Product/Process Change Notice (PCN)

PCN #: PCN_AsPCCA_20180312

Product Affected: WA-PCCA 726141002

Before change:

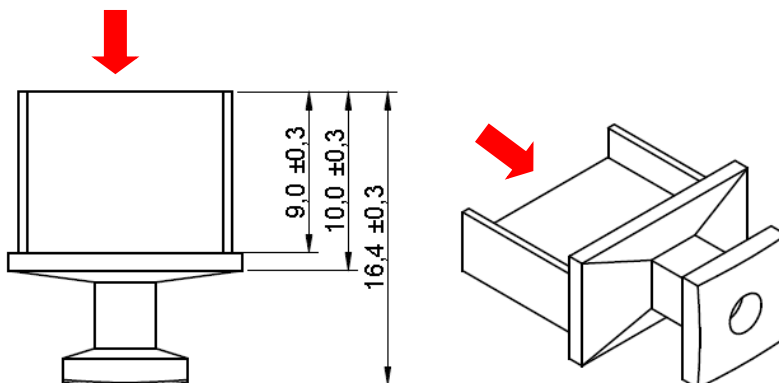
In order to enhance the product quality and reliability, Würth Elektronik will add a chamfer on the insertion area of 1,0 x 30°.

All products with date code 2018-03-12 or later will be affected by this change.
